Addendum No. 3 to the
Environmental Impact Assessment
of January 2016 and its First (July, 2016) and Second Addendums, (April 2018)
For the
Dhaka Mass Rapid Transit Development Project

Prepared for
Dhaka Mass Transit Company Limited

May 2019

DHAKA MRT LINE-6 ROUTE MAP, PACKAGING & ASSOCIATED FACILITIES LOCATIONS

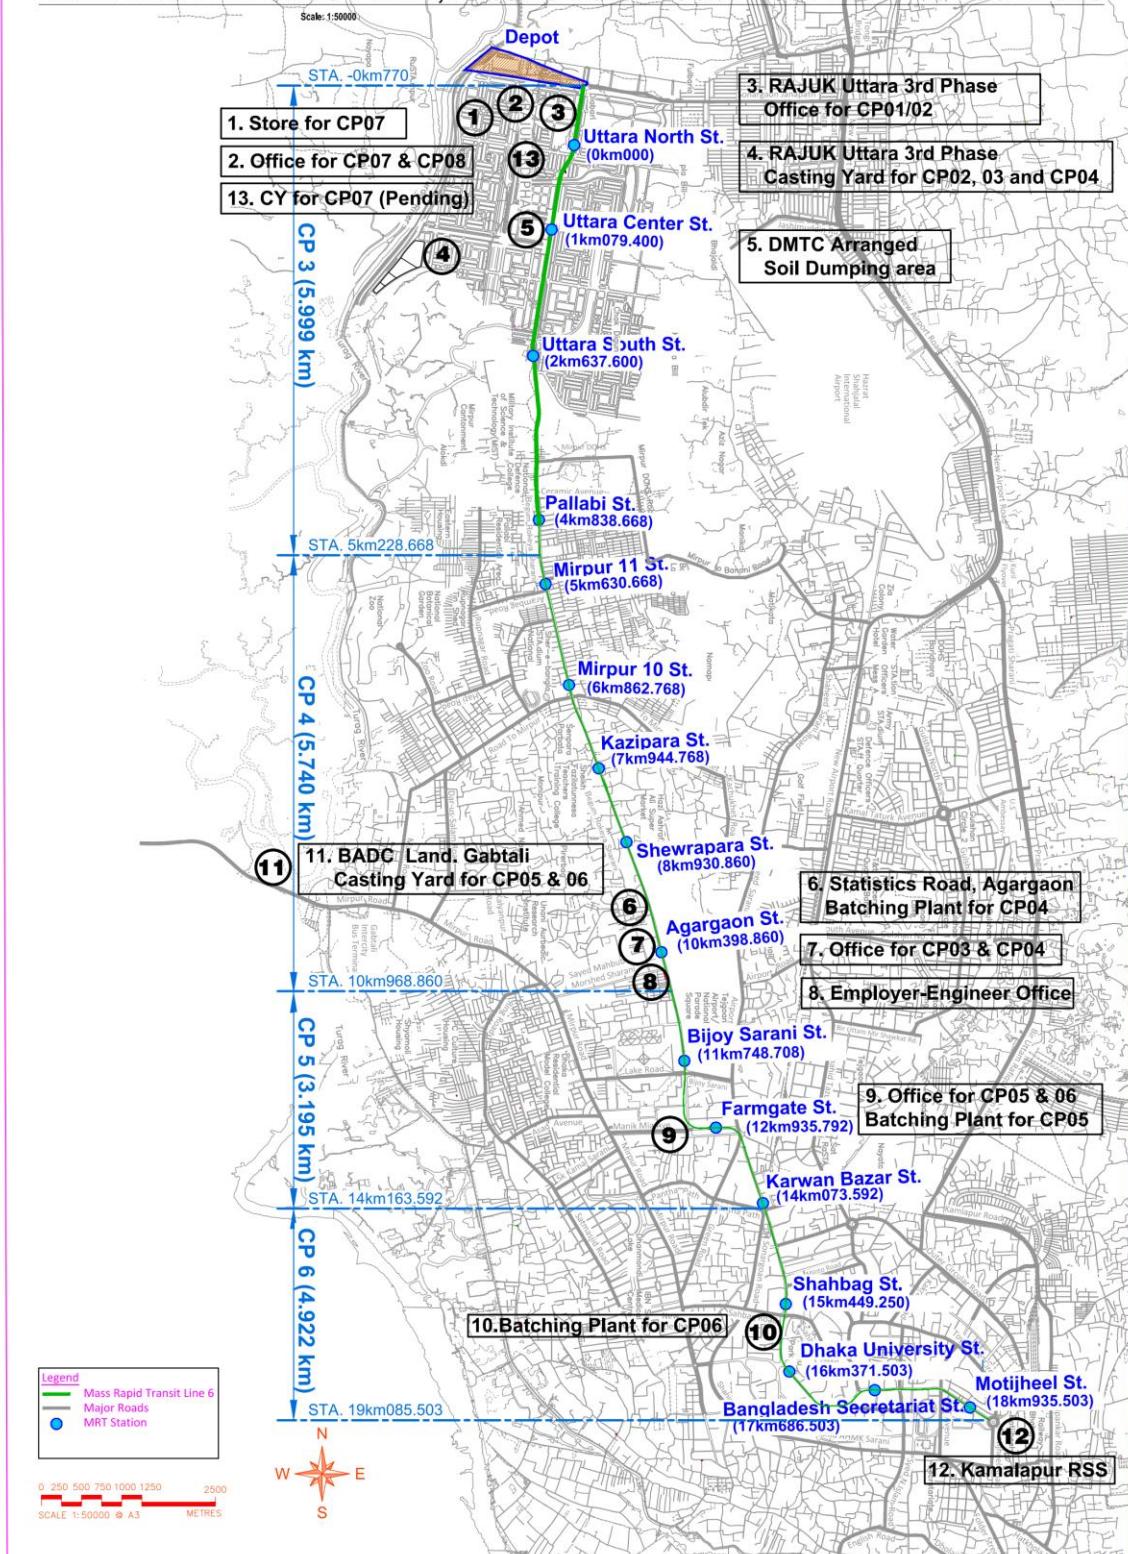
1. Chapter 3, Sec. 3.3.6: Temporary Construction Facilities (Note this revision also applies to Item 4 of Addendum No. 1 and Item 2 of Addendum No. 2)

Replace the paragraph with the following:

“Seven locations have been identified for temporary construction facilities for use under contracts CP-3 – CP-8 (see the next section). These six sites are now confirmed, and are located as shown in Figure 3-12. Environmental aspects of these sites are evaluated in Chapter 6.”

Update Figure 3-12 contained in the EIA with the following: (next page; note: this figure was previously updated in Addendum 2)
